Additional Information

Revision of the approved methodology TH_AM003

“Energy Saving by Introduction of High Efficiency Inverter Type Centrifugal Chiller”

Figure 1: Catalogue COP values of inverter-type centrifugal chillers marketed in Thailand

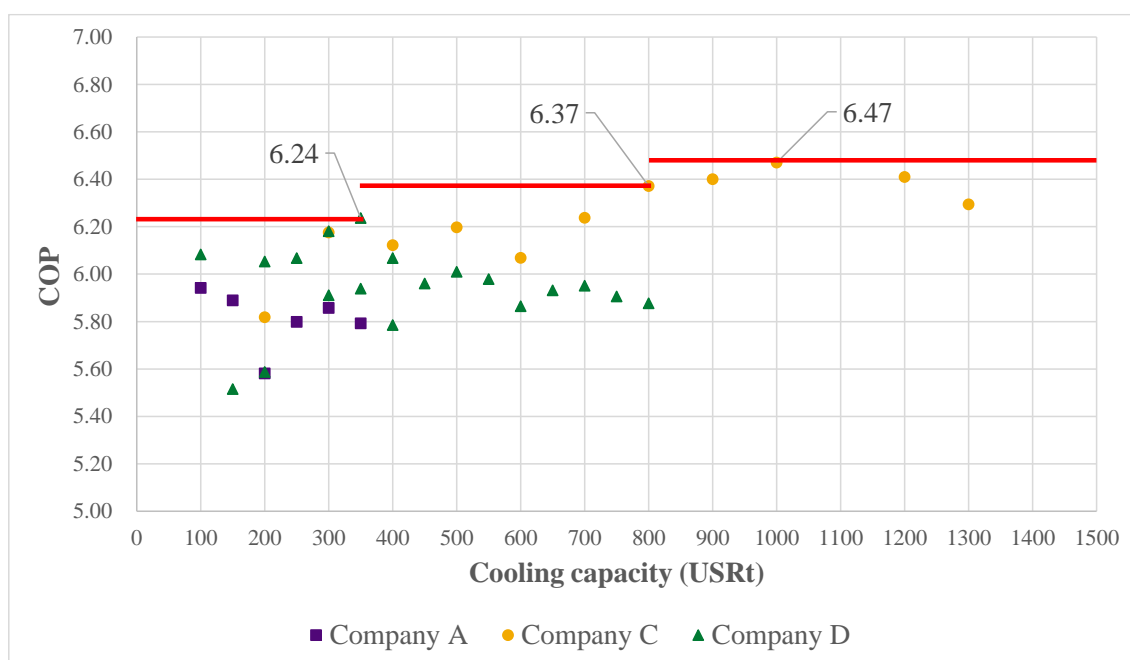
Comparing the COP values of inverter type centrifugal chillers recently marketed in Thailand plotted in **Figure 1** with the default COP values which are set in the JCM methodology TH_AM003 version 1.0 shown in **Table 1**, improvement of values can be observed.

Figure 1 shows that similar COP values fall into a certain cooling capacity range. In order to ensure the conservativeness, the highest COP values (i.e., COP values of the most efficient inverter type centrifugal chillers) within each cooling capacity range are set as the default COP values as shown in **Table 2** below.

Therefore, it is concluded that the default COP values need to be updated to ensure conservativeness and net emission reductions.
